# City of Santa Fe, New Mexico

# memo

2025-011227-HDRB, 925 Canyon Rd., Downtown & Eastside Historic District, non-contributing, Trey Jordon, agent for John and Mary Ann Vigil and Concepcion Lujan, owners, requests a status review with primary façade designation, if applicable.

Figure 3: Construction Dates

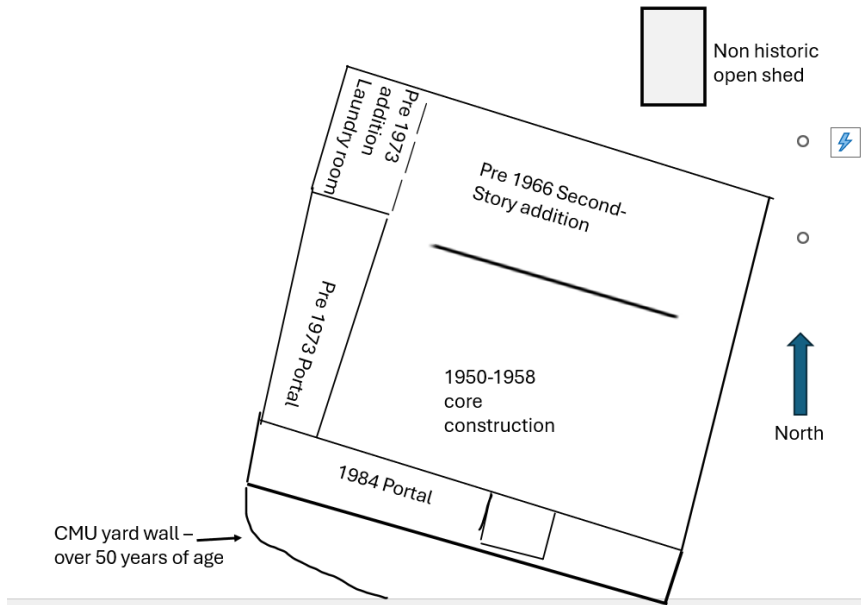
Staff disagree with the HCPI recommendation. All of the additions on the property are historic outside of the portals. The original 1950s adobe section of the building has deep inset fenestrations and is characteristic of the buildings on this streetscape. The additions with two stories at the base of the hill are typical of the time these additions were constructed and are characteristic of this streetscape. Staff finds that this structure contributes to this streetscape.

Figure 4: Façade Diagram

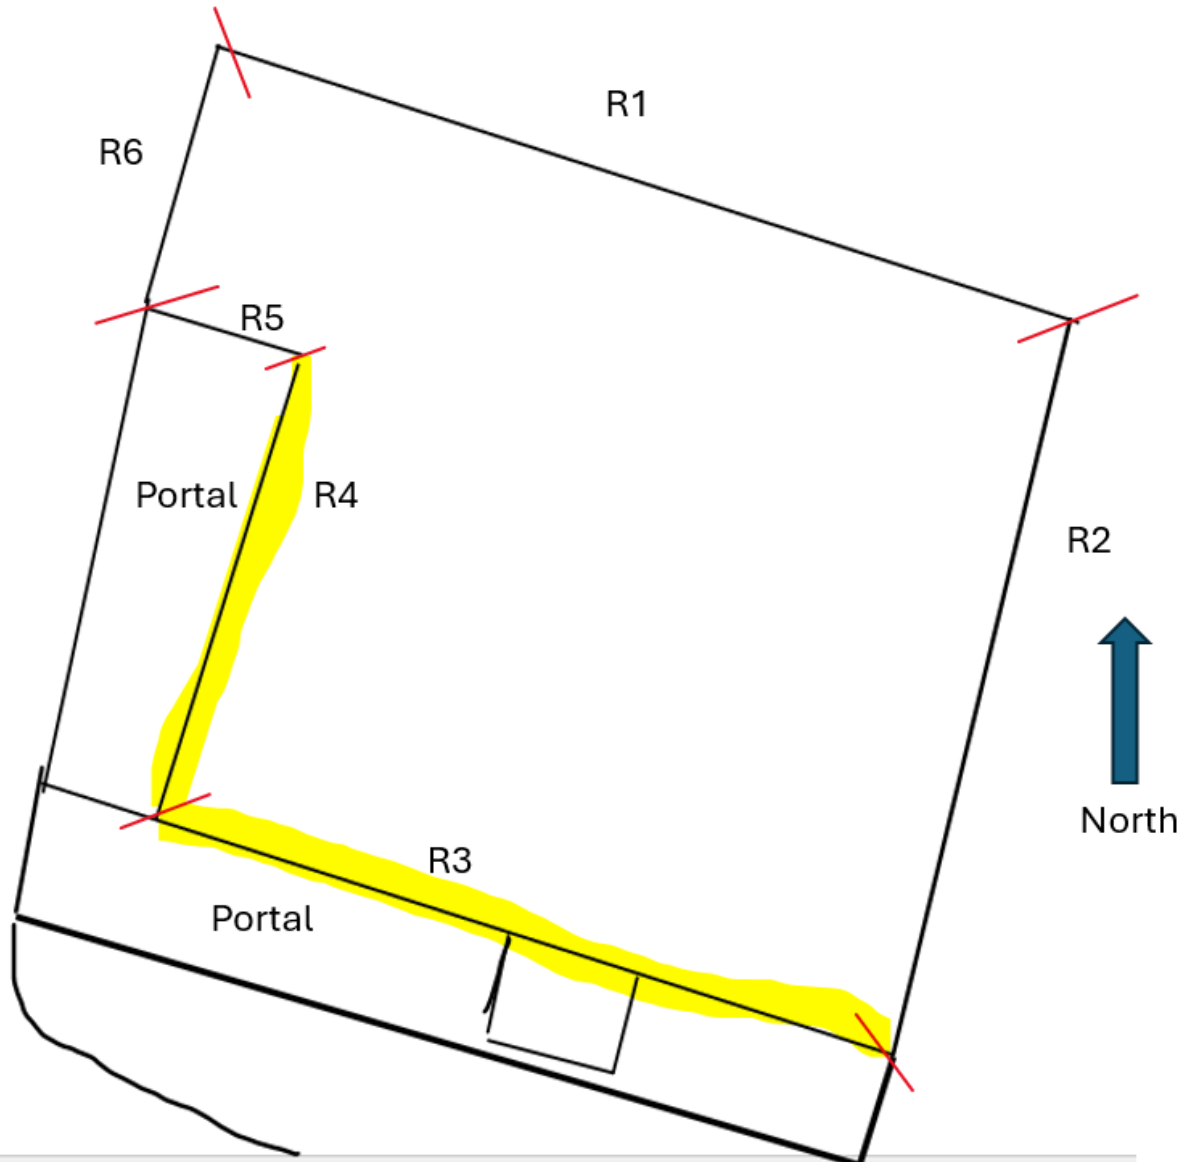
Staff recommends the historic status of the structure be upgraded to contributing with the south and west façades of the original 1950s building as primary (R3 and R4), excluding the non-historic windows and non-historic portal, per 14-5.2(C) Designation of Significant, Contributing or Noncontributing Status Within Historic Districts.
